**BEFORE THE
PUBLIC SERVICE COMMISSION
STATE OF NEW YORK**

Case No. 10-T-0139

**APPLICATION OF CHAMPLAIN HUDSON POWER EXPRESS, INC. AND CHPE
PROPERTIES, INC. FOR AN AMENDMENT TO CERTIFICATE OF
ENVIRONMENTAL COMPATIBILITY AND PUBLIC NEED**

EXHIBIT A
ADDENDUM

PROJECT TITLE CHAMPLAIN HUDSON POWER EXPRESS TRANSMISSION DEVELOPERS, INC.	LOCATIONS	
AECOM	DRAWING TITLE TYPICAL TRENCH CROSS SECTION WITH PVC CONDUIT	DATE: 9/26/2019
		DRAWING NUMBER: FIG 7.2A

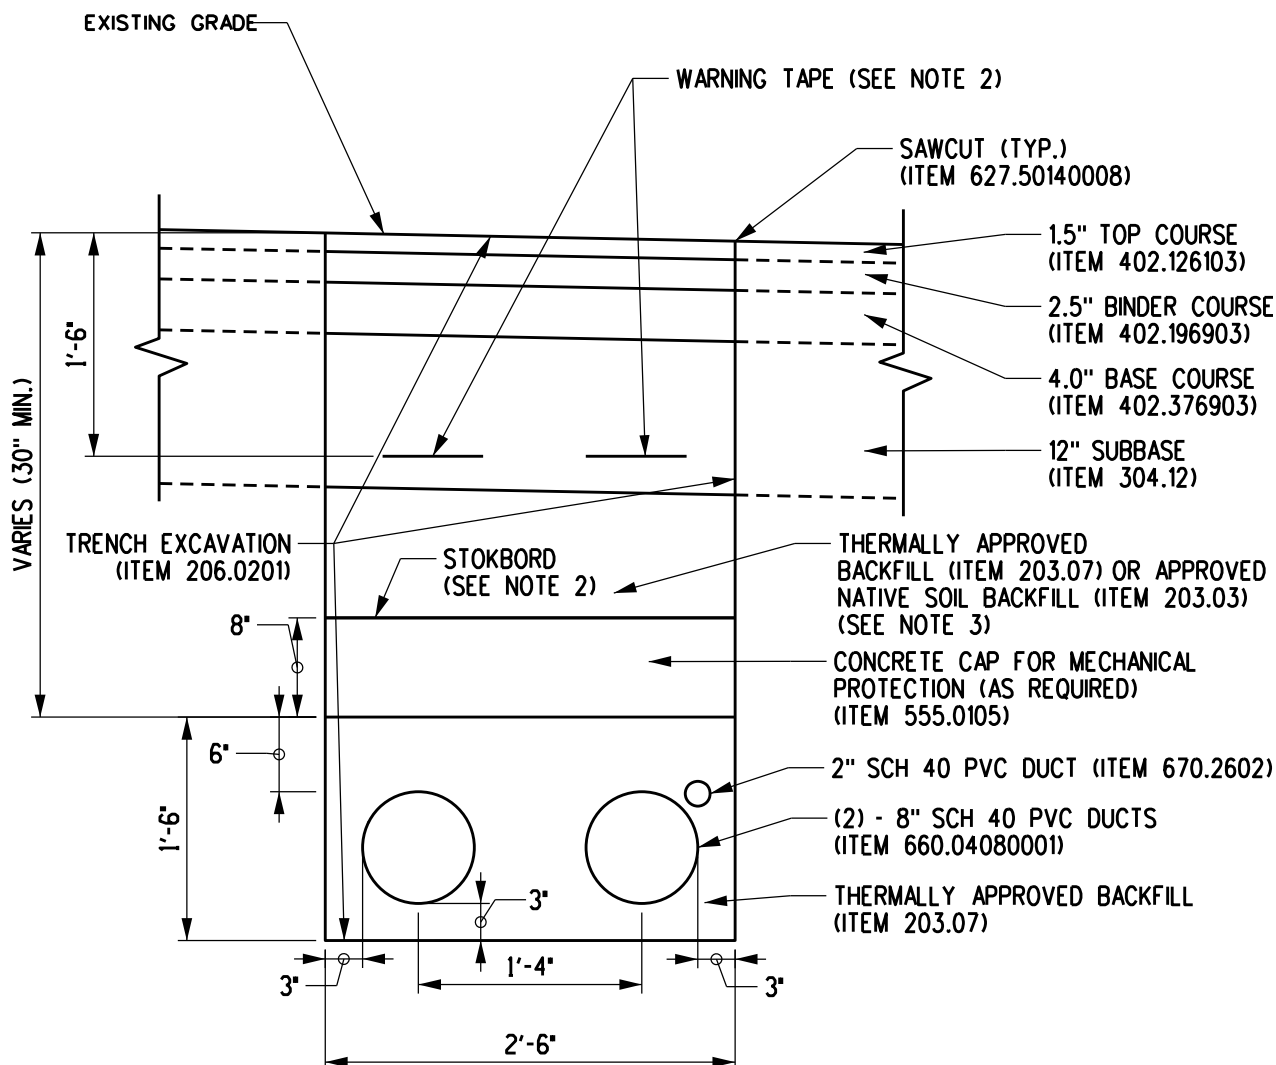
- 15. As noted above, the Applicants have undertaken a comprehensive and ongoing review of the Project Documentation. As a result of this exercise, the Applicants have concluded that one of the “typical” installation detail design drawings appearing in the Project Documentation should be supplemented to reflect the Applicants’ interest in installing the cables within a conduit along overland portions of the Project. Currently, the Project Documentation only contemplates direct burial of the cables in an open trench.

- 16. This particular change is described in detail in an addendum to Section 7 of the Project Best Management Practices (the “Addendum”). The change results in a number of benefits, as further explained and quantified in the Addendum:

It is important to note that the width and depths of the trenches will remain unchanged, as will the size and frequency of the splice vaults, from those associated with the direct burial technique. Thermal impacts to surrounding soils will also be slightly reduced by virtue of the insulating effect of the conduits.

- 17. To achieve this Project design improvement and to make the appropriate complementary update of the administrative record, the Applicants hereby submit the Addendum and accompanying supplementary design drawing, both of which are attached hereto and identified as Exhibits “A” and “B,” for inclusion in the Project Documentation.
